TRANS/WP.29/2000/23

PROPOSAL FOR DRAFT SUPPLEMENT 1 TO REGULATION No. 107

(Double-deck large passenger vehicles)

Transmitted by the Working Party on General Safety Provisions (GRSG)

"5.7.4. Access to escape hatches

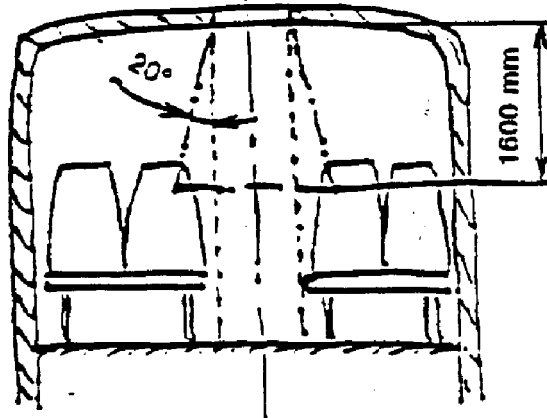
Paragraph 5.7.4., amend to read:

- 5.7.4.1. If one or more escape hatches are fitted in the roof, at least one escape hatch shall be located such that a four-sided truncated pyramid having a side angle of  $20^\circ$  and a height of 1,600 mm touches part of a seat or equivalent support. The axis of the pyramid shall be vertical and its smaller section shall contact the aperture area of the escape hatch. Supports may be foldable or movable provided they can be locked in their position of use. This position shall be taken for verification.

- 5.7.4.2. When the structural thickness of the roof is more than 150 mm, the smaller section of the pyramid shall contact the aperture area of the escape hatch at the level of the outside surface of the roof."

Figure 11

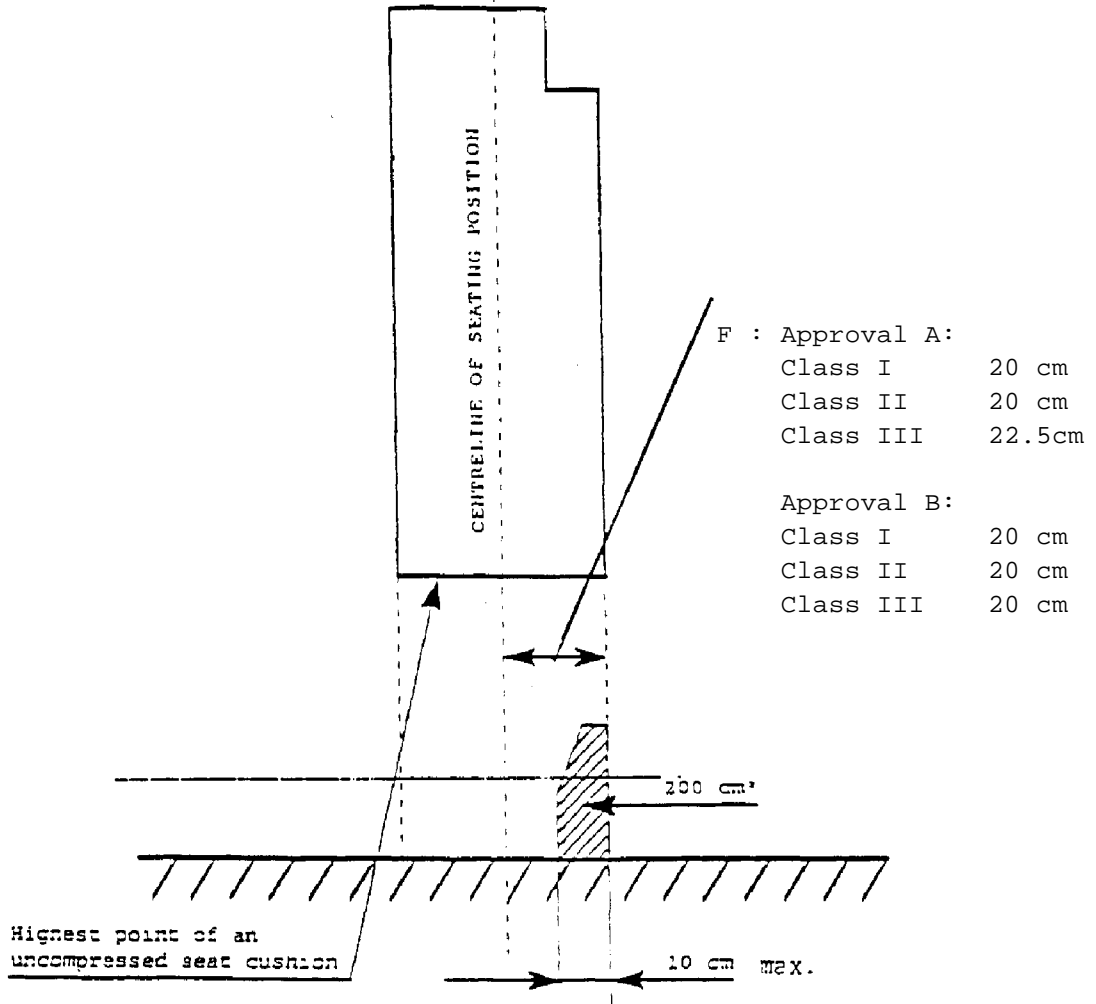
Annex 3, figure 11, replace by the following figure:

PERMITTED INTRUSION IN LOWER PART OF PASSENGER SPACE  
(See paragraph 5.7.9.6.2.3.)

"Figure 16

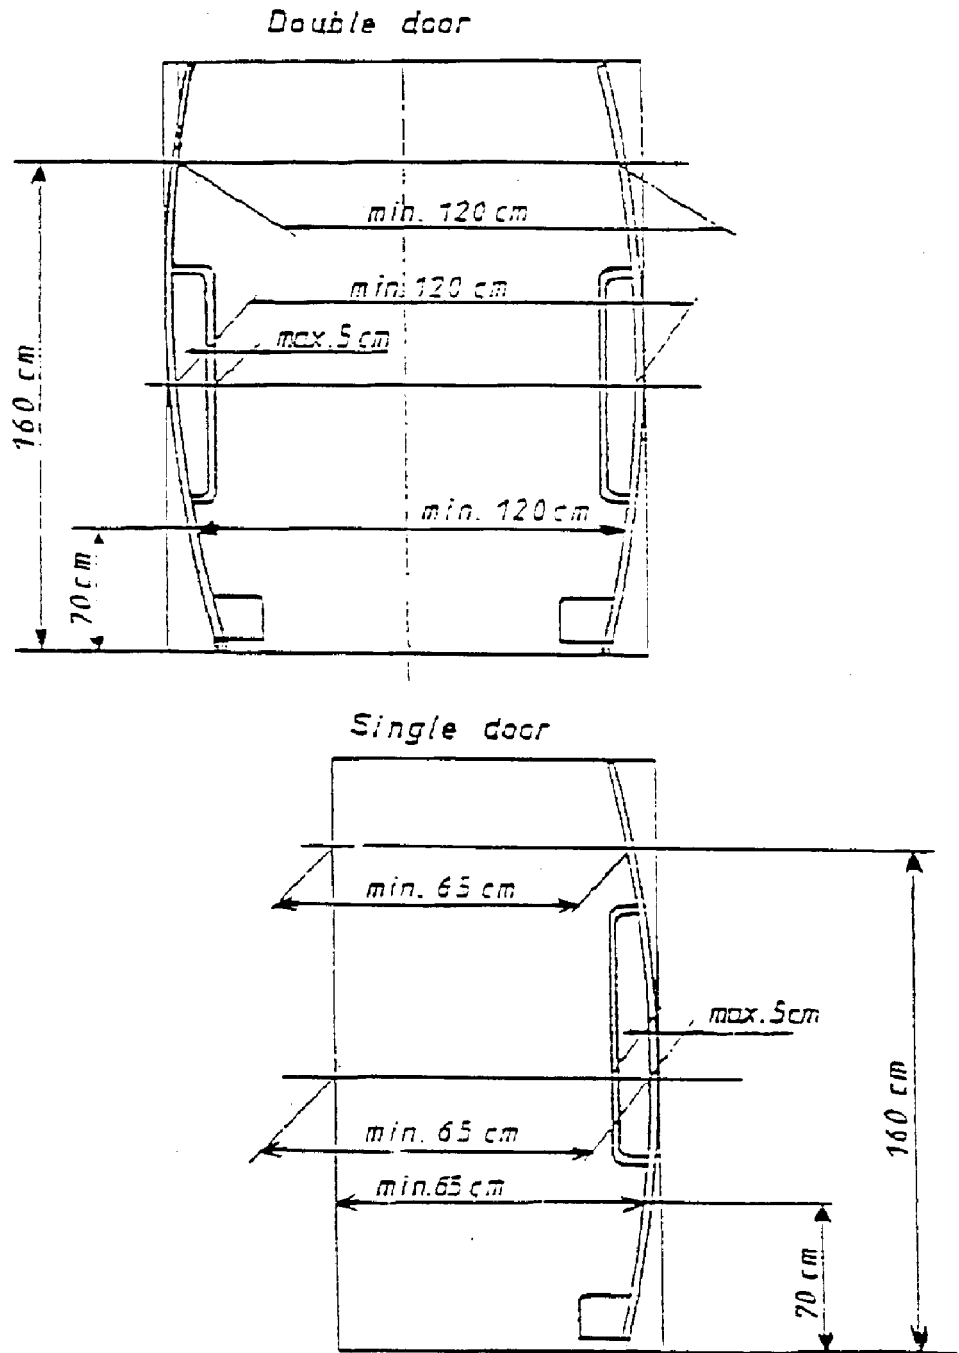
" . . . . the following minimum dimensions (see also annex 3, figure 16)."

"... The required width shall be ensured in the height of 70 to 160 cm related to the level of the first step (see annex 3, figure 16)."

Annex 3, insert a new figure 16, to read:

Figure A

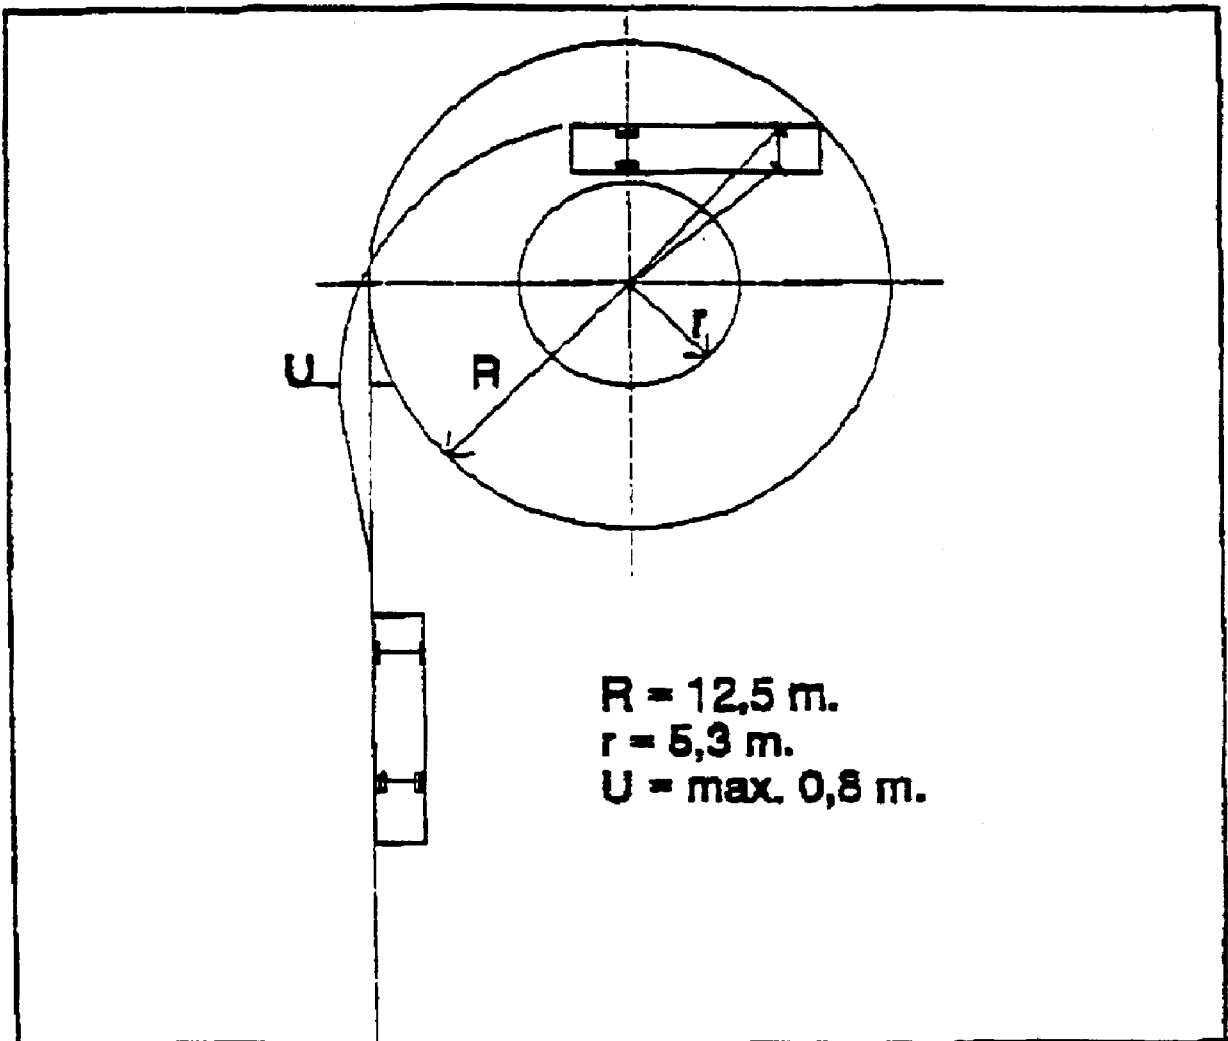
" ... circular track 7.2 m wide (see annex 4 figures A and B)."

"5.10.3. With the vehicle stationary, a vertical plane tangential to the side of the vehicle and facing outwards from the circle shall be established by marking a line on the ground. In the case of an articulated vehicle the two rigid portions shall be aligned with the plane. When the vehicle moves from a straight line approach into the circular area described in paragraphs 5.10.1. and 5.10.2. above, no part of it shall move outside of this vertical plane by more than 0.8 m (see annex 4, figure A) in the case of a rigid vehicle, or by more than 1.2 m (see annex 4, figure B) in the case of an articulated vehicle."

Annex 4, figures A and B, replace by the following figures (figure C being deleted):
